Index 11860 Single Column Ground Sign

COMMENTARY

COMMENTS AND RESPONSES

ALUMINUM SOIL PLATE DETAIL

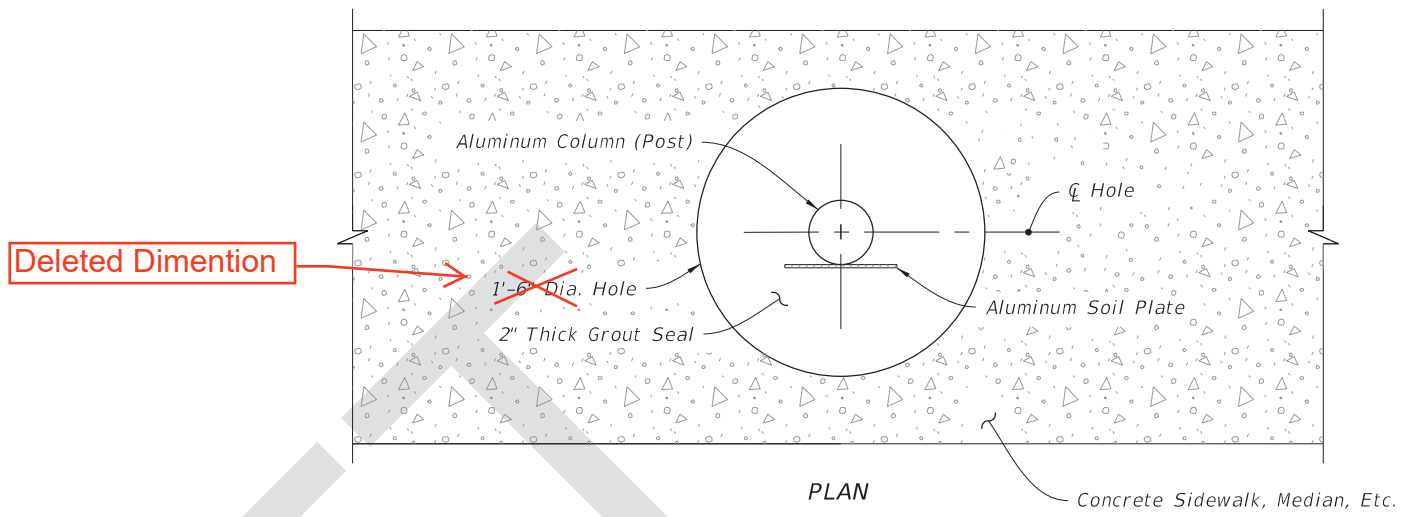
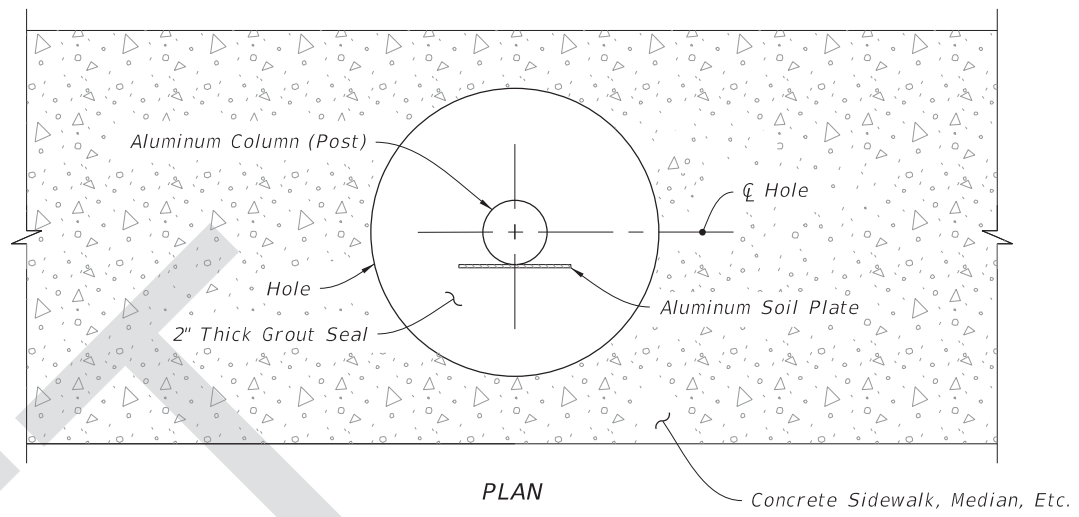
Sheet 5: Deleted the CONCRETE/STUB DETAIL; Added DETIAL 'B' Optional Slotted Holes; Changed the Soil Plate Dimension in the ALUMINUM SOIL PLATE DETAIL; Changed the hole diameter to 8" and soil plate width to 7" for DRIVEN POST DETAIL; Added Plan View to the DRIVEN POST DETAIL.

Deleted Dimension

DRIVEN POST DETAIL

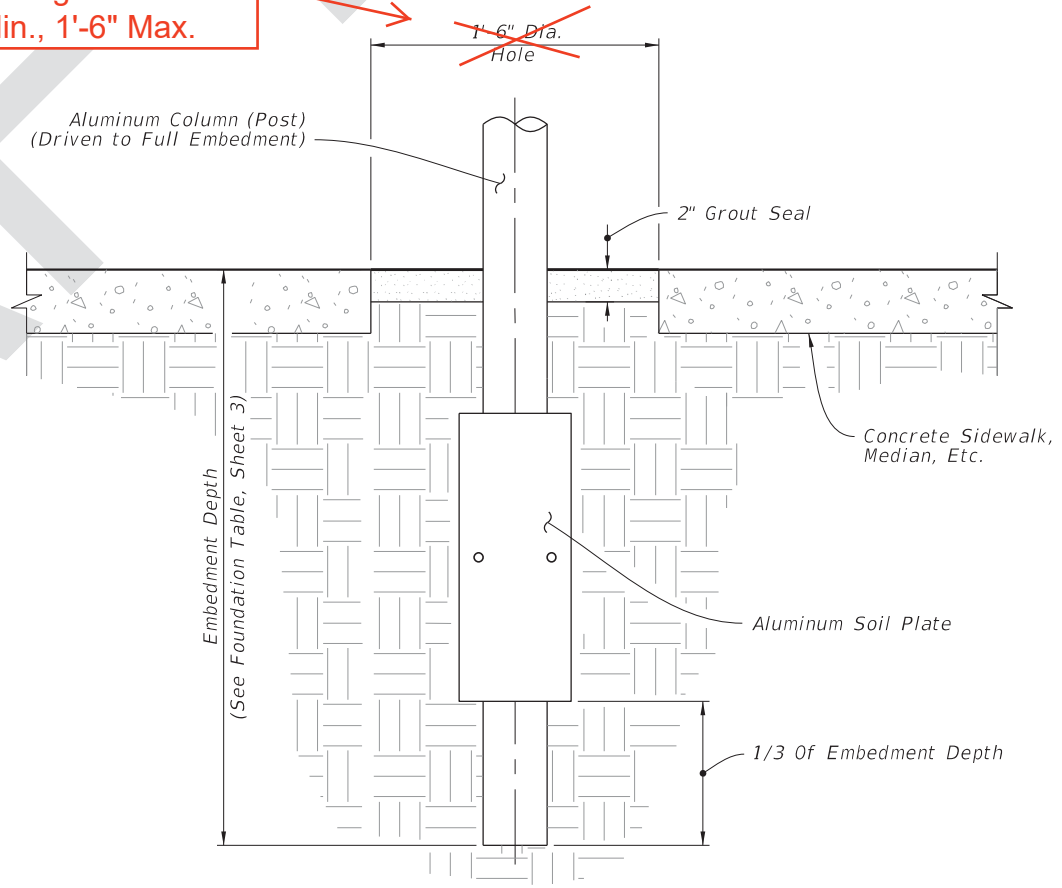
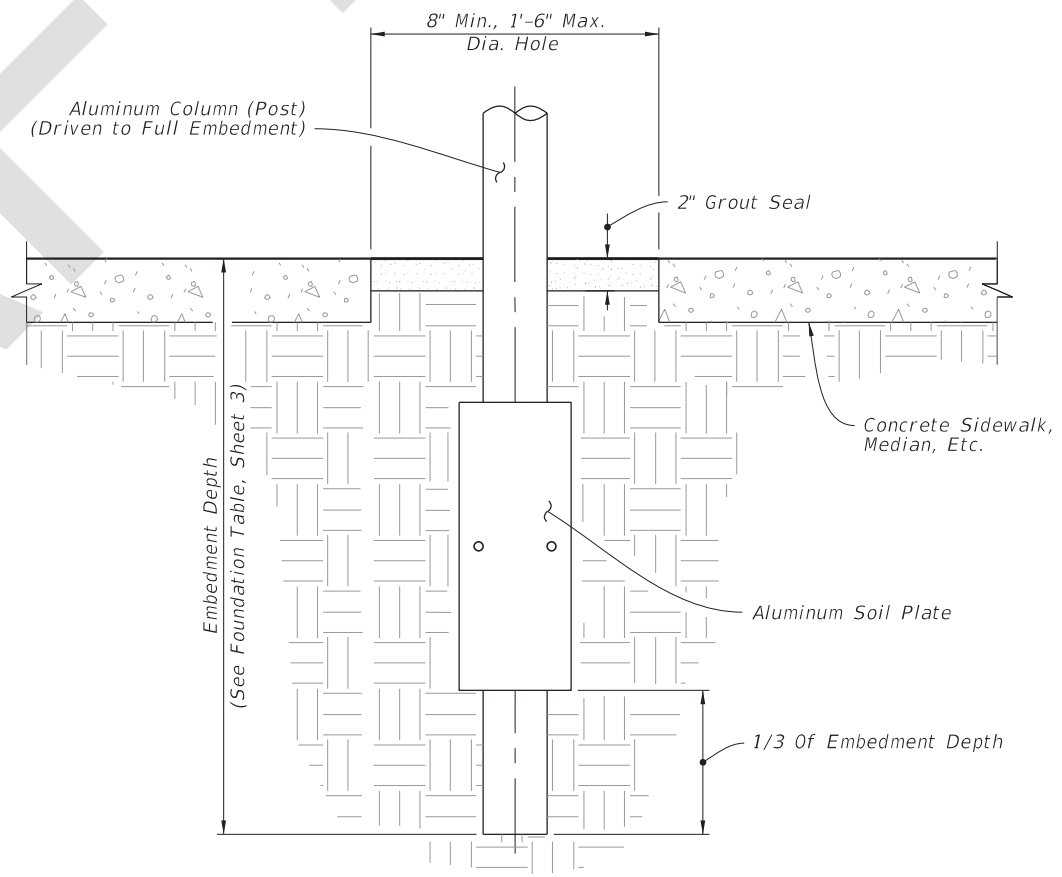
The dimensions of the soil plate on sheet 5 of 9 have been changed to 7" wide, but the diameter of the hole in concrete remains unchanged at 1'6". Is there a reason that the diameter of the hole is still 1'6"? Would the Department consider changing it to 12" now that the smaller soil plate is used?

The dimension will be changed to accommodate a range from 8" minimum to 1'-6" maximum.

Changed to 8" Min., 1'-6" Max.
